HISTORIC AND DESIGN REVIEW COMMISSION

HDRC CASE NO: 2019-080
ADDRESS: 328 E JOSEPHINE
LEGAL DESCRIPTION: NCB 975 (BOEHLER'S SUBD), BLOCK 18 LOT 15
ZONING: C-3, RIO-2
CITY COUNCIL DIST.: 1
APPLICANT: Kristen Weber/Don B McDonald Architect
OWNER: Rio Perla Properties, LP
TYPE OF WORK: Relocation of structure, additions, exterior modifications, site work
APPLICATION RECEIVED: February 15, 2019
60-DAY REVIEW: April 16, 2019
REQUEST:

The applicant is requesting a Certificate of Appropriateness for approval to perform various scopes of work to the Boehler's Bar & House including the relocation of the Boehler's Bar and additions, exterior modifications and rehabilitation of the Boehler's Bar and House. Within this scope of work, the applicant has proposed the following:

Site Plan

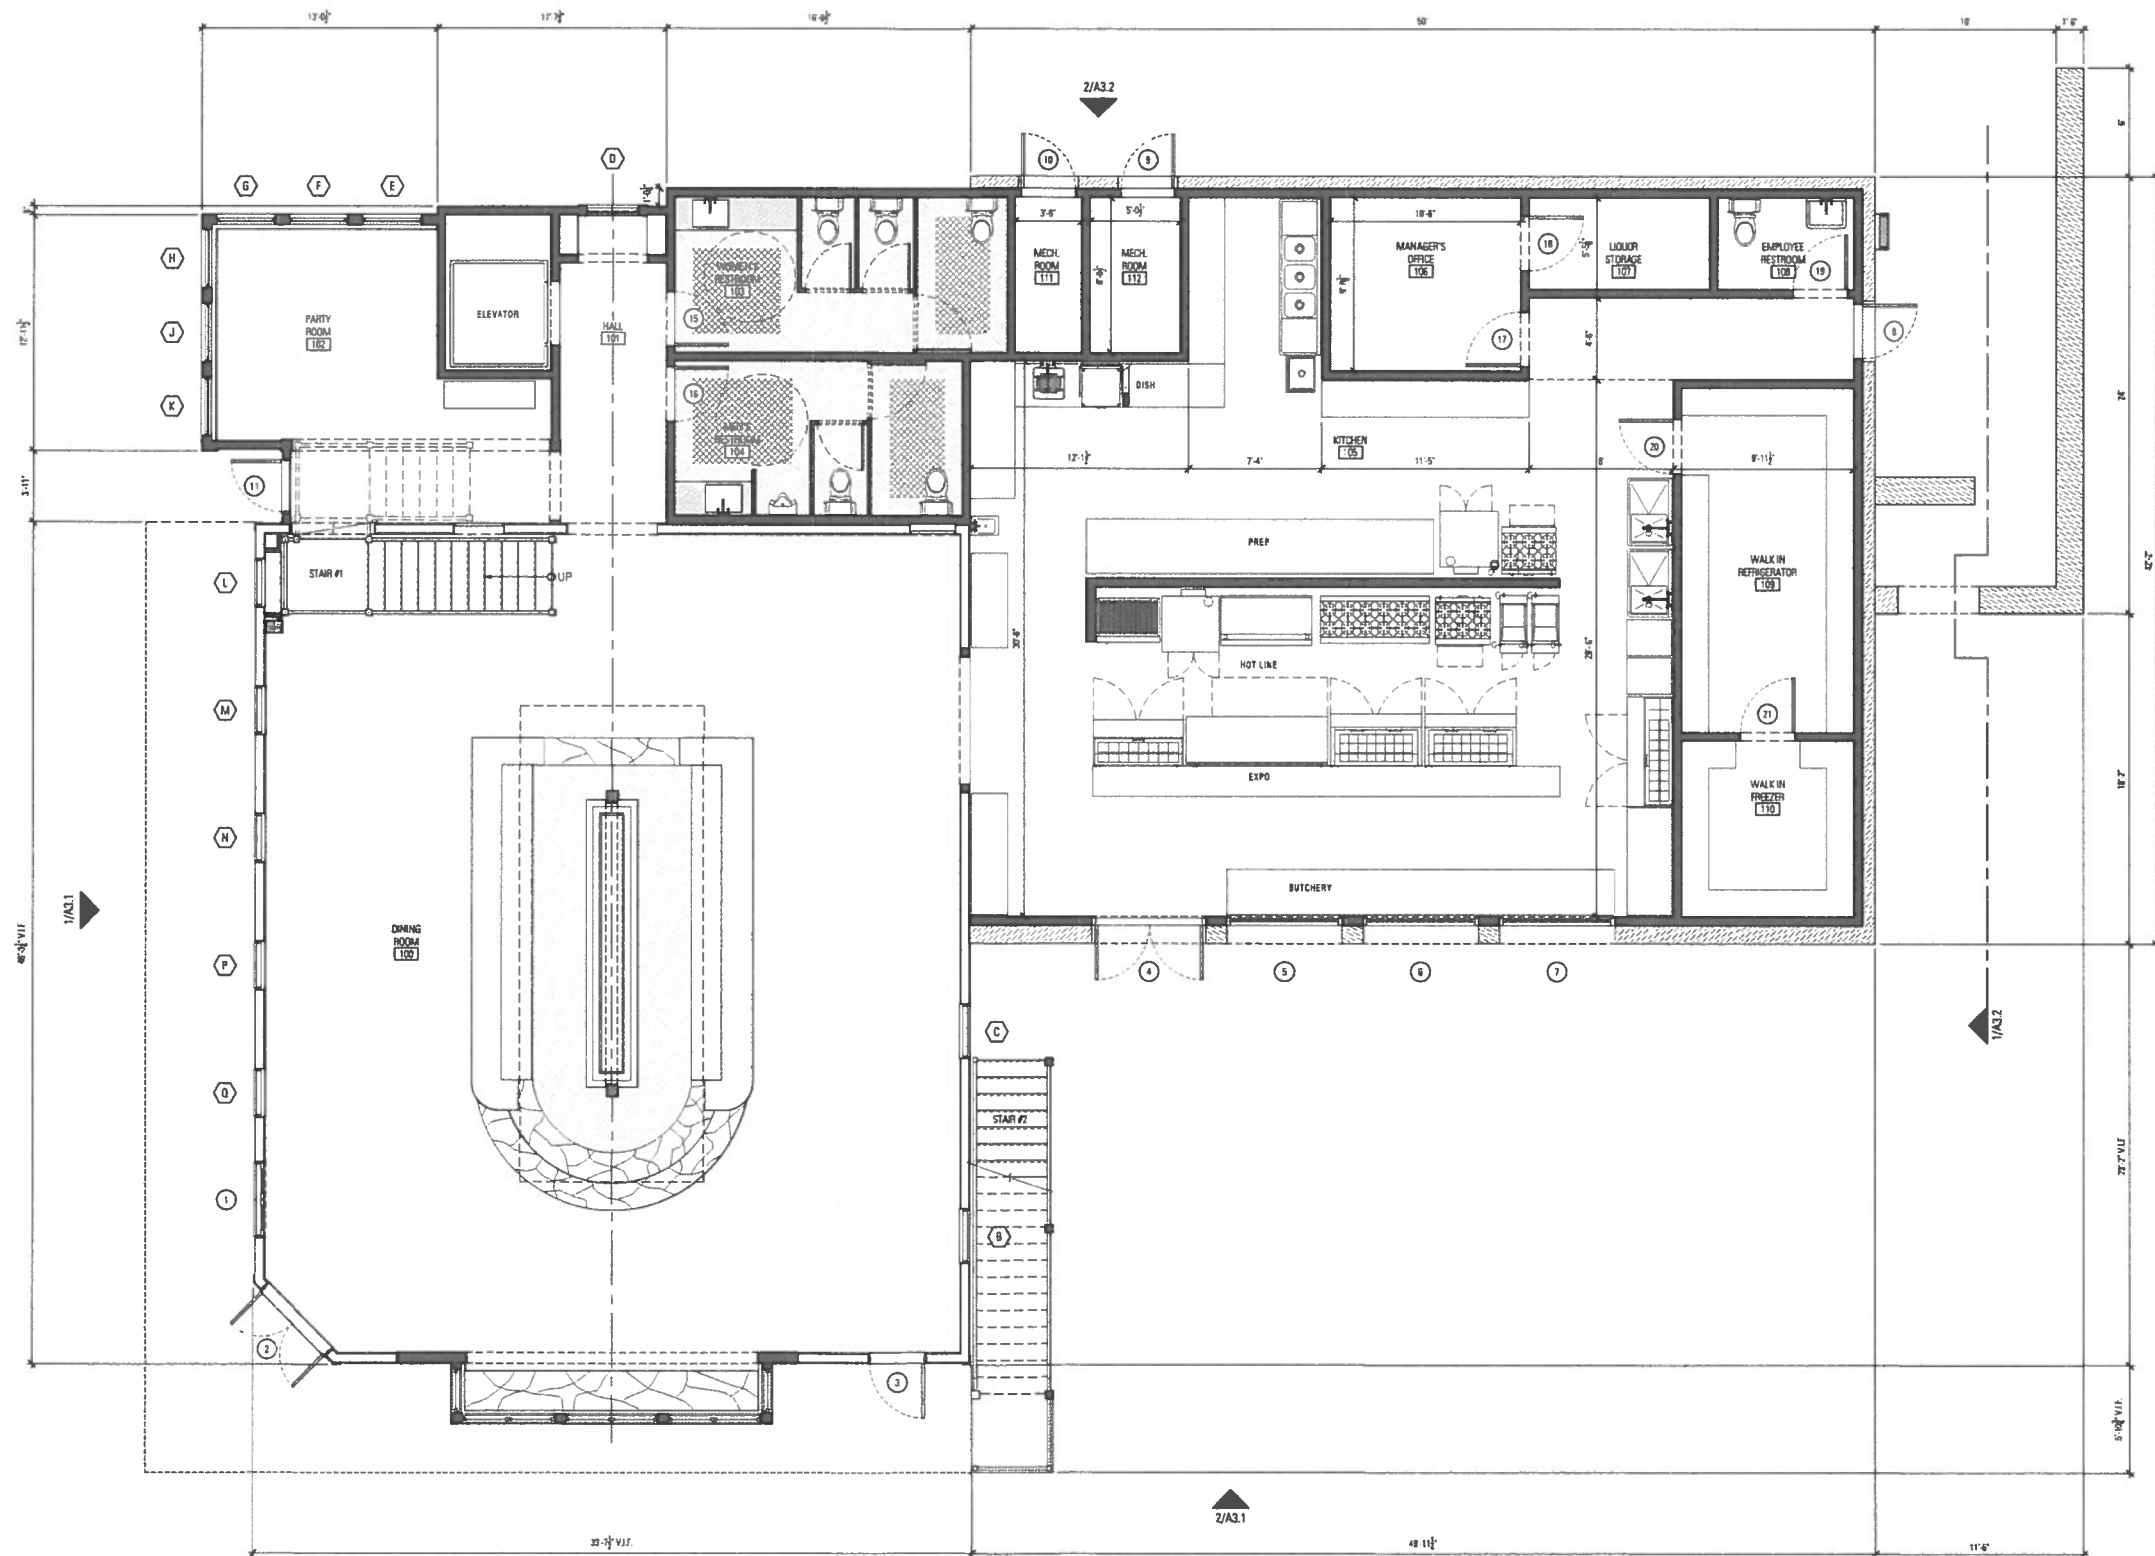
- 3a. COURTYARD – The applicant has proposed to construct a courtyard on the southwestern corner of the site, near the intersection of E Grayson and Avenue A. The proposed courtyard is to feature an outdoor dining area. Generally, staff finds the proposed courtyard area to be appropriate.
- 3b. PARKING LOT – The applicant has proposed to construct a parking lot on the lot at the corner of E Josephine and Avenue A. Staff finds the proposed parking lot to be appropriate. While not appropriate as a façade material, staff finds the rubble limestone appropriate as a landscaping and buffer wall material.

Exterior Elevations

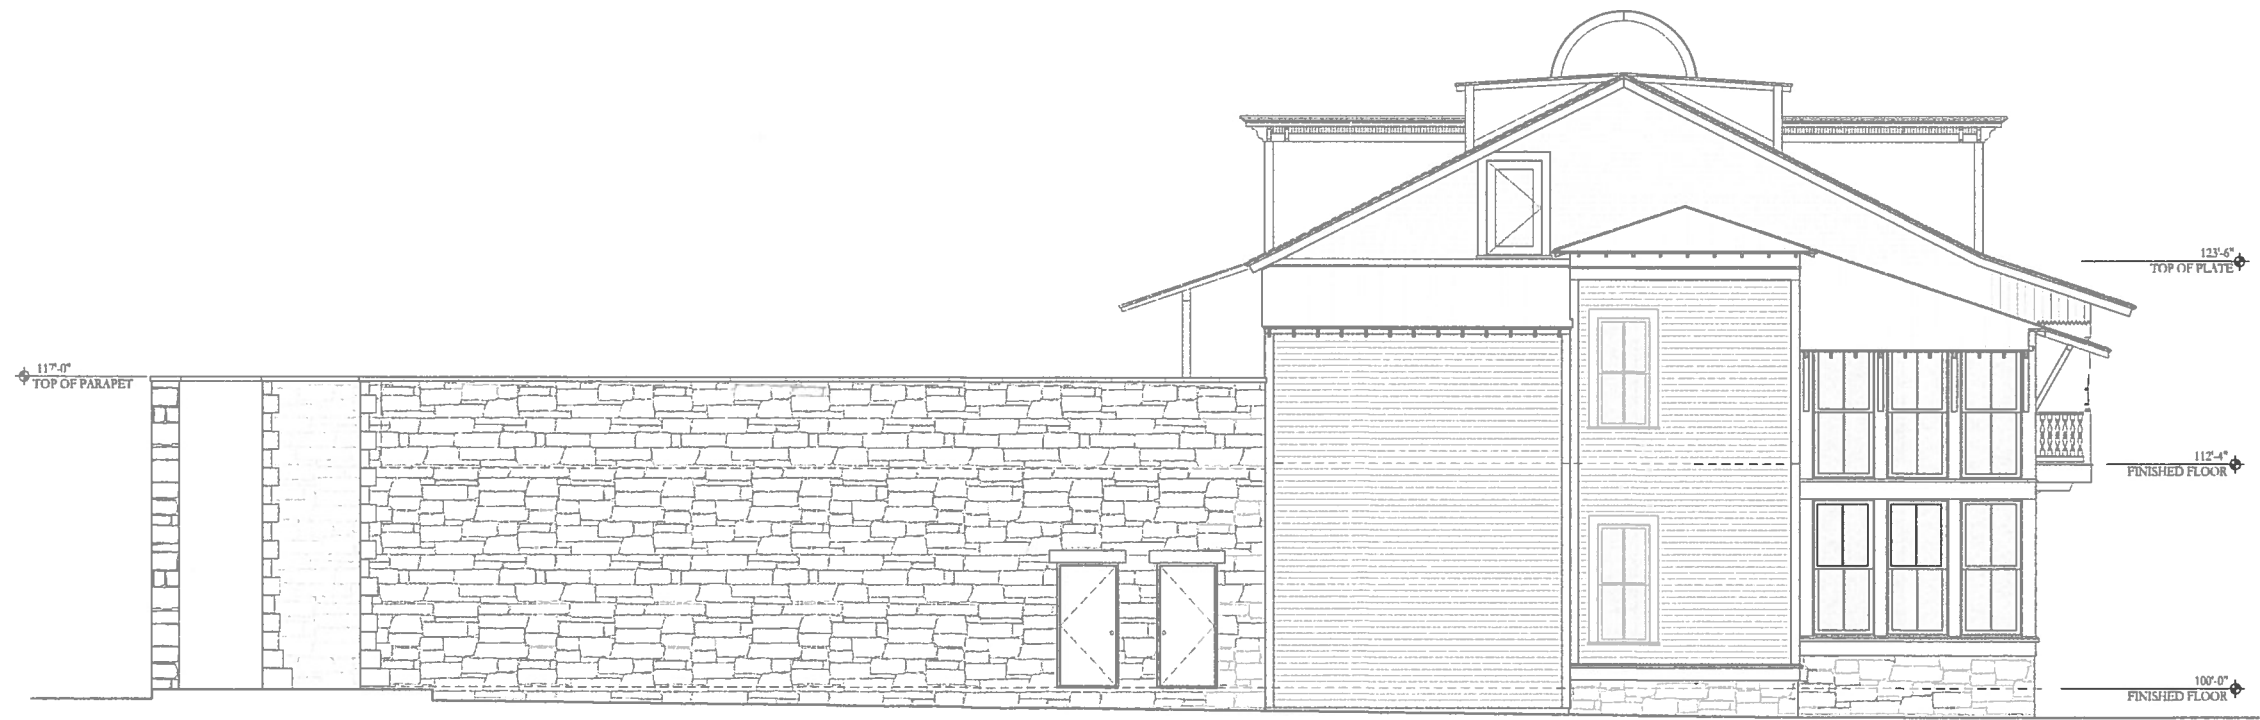
- 1c. BAY WINDOW INSTALLATION – On the front façade, the applicant has proposed to install a new bay window. Staff finds the proposed bay window to be an addition to the primary façade. The UDC Section 35-676(j) notes that additions and alterations shall be constructed in such a manner that if such additions or alterations were removed in the future, the essential form and integrity of the building would be unimpaired. Staff finds that the applicant shall construct the proposed addition in a manner than is reversible.

- 1e. KITCHEN ADDITION – The applicant has proposed to construct a kitchen addition to the north façade of the historic structure to feature one story in height. Generally, staff finds the location and massing of the proposed addition to be appropriate; however, staff finds that the proposed rubble stone limestone cladding to be inconsistent with the UDC Section 35-676(i), which notes that new and contemporary designs should feature materials that are consistent with the character of the property, neighborhood and environment. Staff finds that in this location, removed from Brackenridge Park, the proposed loose rubble limestone is inappropriate. Additionally, the UDC Section 35-676 (c) notes that all buildings, structures, objects, and sites shall be recognized as products of their own time. Alterations that have no historical basis and which seek to create an earlier appearance are prohibited. Staff finds that the use of rubble stone is not consistent with the character of the property. Brick cladding or an alternative material would be more consistent with the period of development of the neighborhood.

- i. That additions and alterations be constructed in such a manner that if such additions or alterations were removed in the future, the essential form and integrity of the building would be unimpaired.
- ii. That all loose rubble stone be eliminated as a cladding material. Alterations that have no historical basis and which seek to create an earlier appearance are prohibited. Staff recommends the applicant use brick or an alternative materials that is more in keeping with the period of development of the property.
- iii. That all new windows feature installation depths, materials and finishes that match those found historically on the structures.

Exterior Elevations

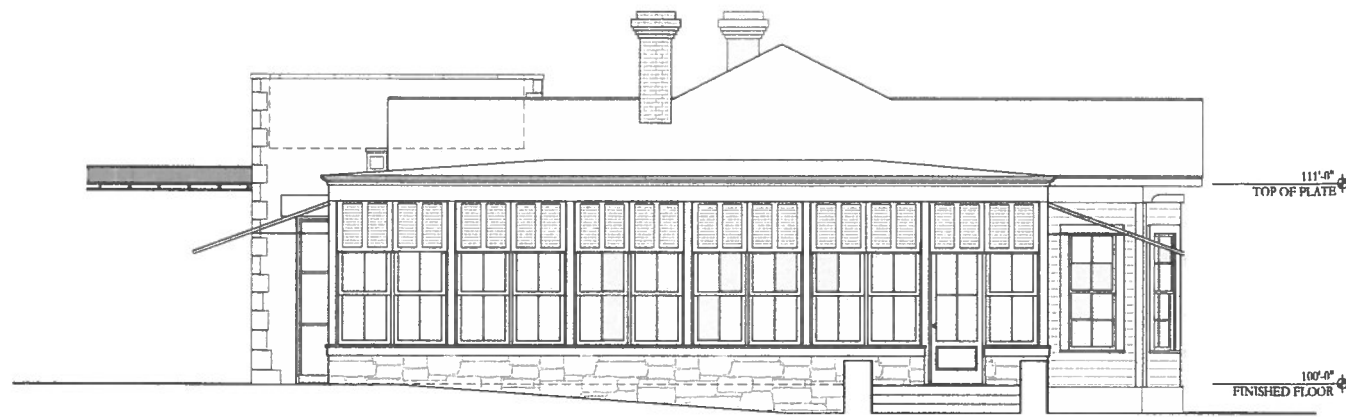
- 1f. KITCHEN ADDITION – The rear (west) elevation of the kitchen addition currently features a blank façade. Staff finds that given the site constraints and neighboring parking structure to the immediate west, the proposed blank wall is appropriate.

- 1h. BALCONY & STAIR ADDITION – On the proposed side (north) façade near the front of the Boehler’s Bar, the applicant has proposed to install an egress stair. The applicant has proposed to construct a balcony addition that will wrap to the side façade of the structure, under which the proposed egress stair will be located. Staff finds the proposed balcony and egress stair additions to be appropriate. The applicant has proposed columns that do not replicate the ornamentation of the original at the balcony addition. Staff finds this to be an appropriate detail to differentiate the balcony addition from the original.

Rye House Exterior

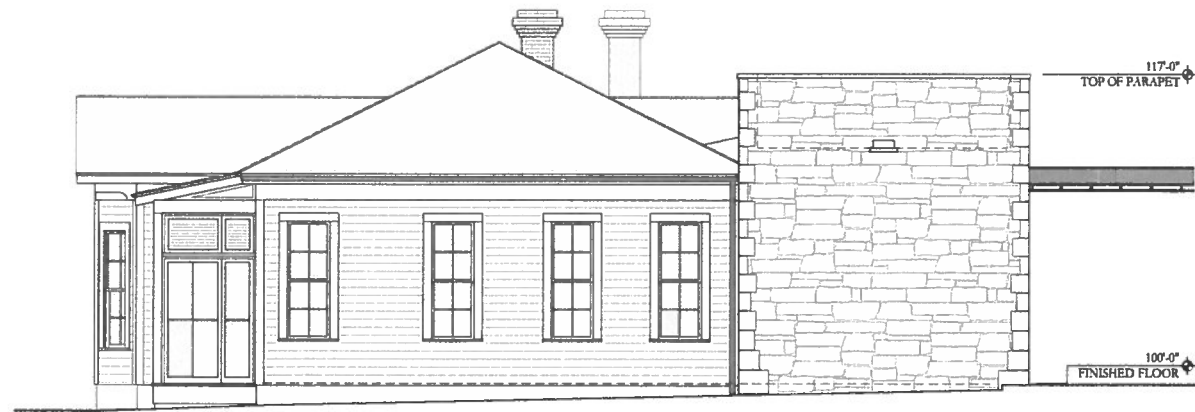
- 2c. WINDOW ADDITION – On the rear (west) of the structure, the applicant has proposed to install a new window opening. Given that this window is on the rear façade, staff finds it appropriate.

- 2d. PORCH ADDITION – The front porch of the structure currently does not exist. The applicant has proposed to construct the porch as a screened element to feature interior dining space. Staff finds that the reconstruction of the porch is appropriate; however, the design should read as a front porch, even if screened.

- 2e. SIDE ADDITION – The applicant has proposed to construct an addition to the side (south) façade to feature dining. The applicant has proposed for the addition to feature a screened porch fenestration panel and a rubble stone base. While staff finds the proposed massing and siting of the proposed addition, as well as the proposed wood siding, staff finds that an alternative base/skirting material should be proposed. Staff finds that in this location, removed from Brackenridge Park, the proposed loose rubble limestone is inappropriate. Additionally, the UDC Section 35-676 (c) notes that all buildings, structures, objects, and sites shall be recognized as products of their own time. Alterations that have no historical basis and which seek to create an earlier appearance are prohibited. Staff finds that the use of rubble stone is not consistent with the character of the property. Brick cladding or an alternative material would be more consistent with the period of development of the neighborhood.

- 2f. REAR ADDITION – The applicant has proposed a rear addition to feature one story in height and loose rubble stone cladding. Generally, staff finds the location and massing of the proposed addition to be appropriate; however, staff finds that the proposed rubble stone limestone cladding to be inconsistent with the UDC Section 35-676(i), which notes that new and contemporary designs should feature materials that are consistent with the character of the property, neighborhood and environment. Staff finds that in this location, removed from Brackenridge Park, the proposed loose rubble limestone is inappropriate. Additionally, the UDC Section 35-676 (c) notes that all buildings, structures, objects, and sites shall be recognized as products of their own time. Alterations that have no historical basis and which seek to create an earlier appearance are prohibited. Staff finds that the use of rubble stone is not consistent with the character of the property. Brick cladding or an alternative material would be more consistent with the period of development of the neighborhood.
